June BAR Action - 525 Ridge Street

BAR 20-06-02

525 Ridge Street

Revised landscape wall material

IMAGES

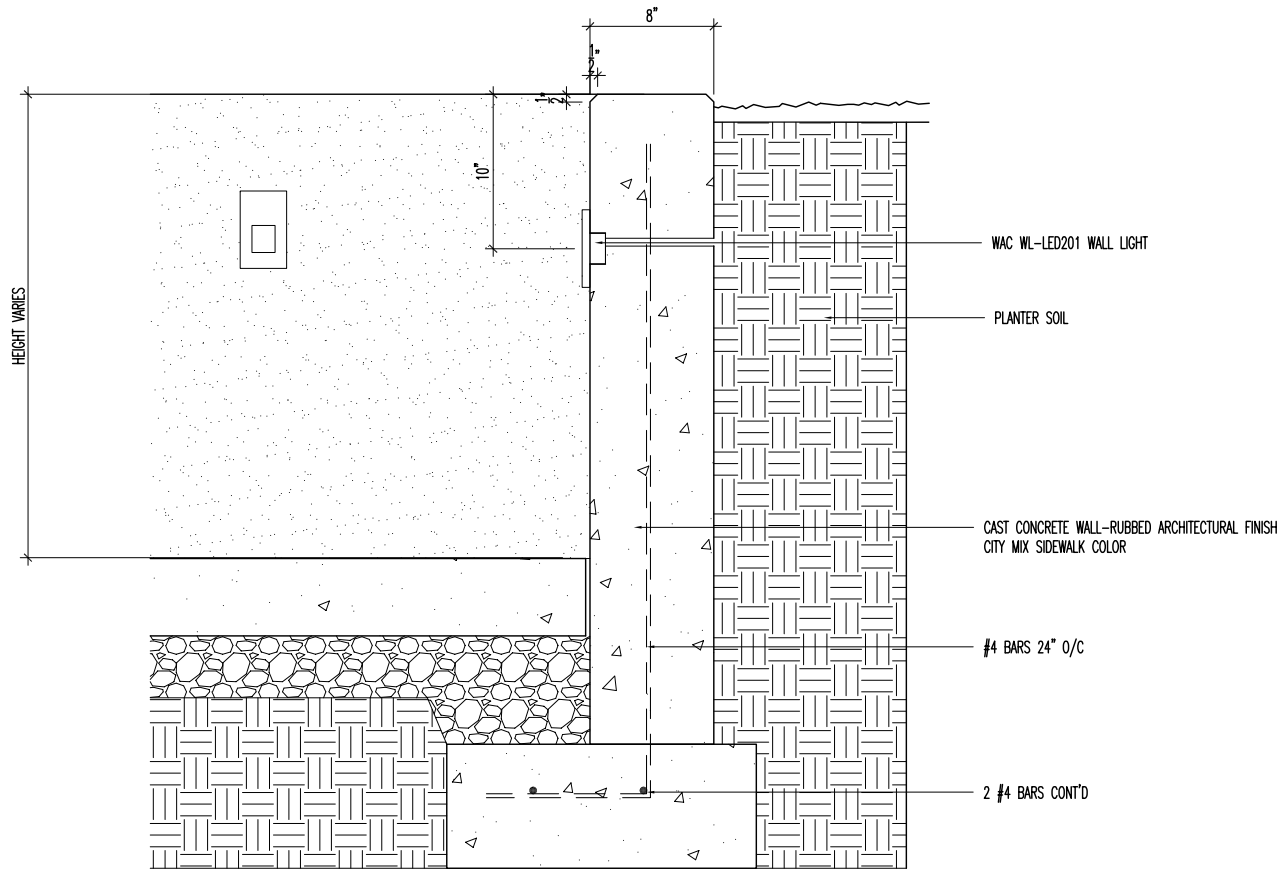
Staff finds the proposed concrete wall appropriate to the ADC and recommends approval.

We request a revision of the approved street curb/wall from the approved Corten steel plate to concrete.

We now propose the wall to be of formed in place concrete with chamfered corners. This material and detail is found two and three houses north of the project and throughout the city. The wall would be cast using 'city mix' concrete color and hand rubbed to a sand finish.

Jody Lahendro moves Having considered the standards set forth within the City Code, including City Design Guidelines for Site Design and Elements, I move to find that the proposed concrete wall satisfies the BAR's criteria and is compatible with this property and other properties in the Ridge Street ADC District, and that the BAR approves the application as submitted
Tim Mohr seconds. Approved (7-0).
